Access Compliance Report

Public Rights-of-Way

(Curb Ramps)

Intersection ID: 25823	Main Street: BANNINGTON_RD	Cross Street: PINEVILLE-MATTHEWS_RD	Location:	SE
ADA ID: B8C74CD7E63B	Ramp Type: BlendTrans1	Initial Pass/Fail: Pass	Overall Compliance: No	Severity Score: 15
Codes/Mitigation Info/Possible Solution		Field Measurements/Component Compliance

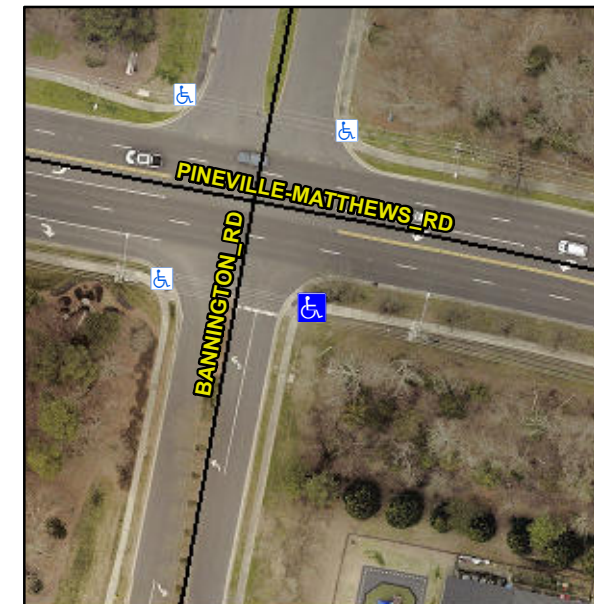
Not Found, R305, R304.5.4

N/A	Ramp inside XWalk1?	N/A	N/A	Ramp inside XWalk2?	N/A
	Road Slope (%)	0.2		Clear Space?	Yes
	Road X Slope (%)	6.0	N/A	Clear Space to XWalk (in)	N/A
Yes	Any Obstructions?	No	Yes	Storm Grate/Utility Hazard?	No
	Obstruction Type			Storm Grate/Utility Type	
		N/A			N/A
			Yes	Surface Condition? (G/P)	Good
			No	Curb Slope (%)	12.4

Remove & Replace Curb Ramp With Two New Directional Ramps or Equivalent. Remove & Replace Gutter.
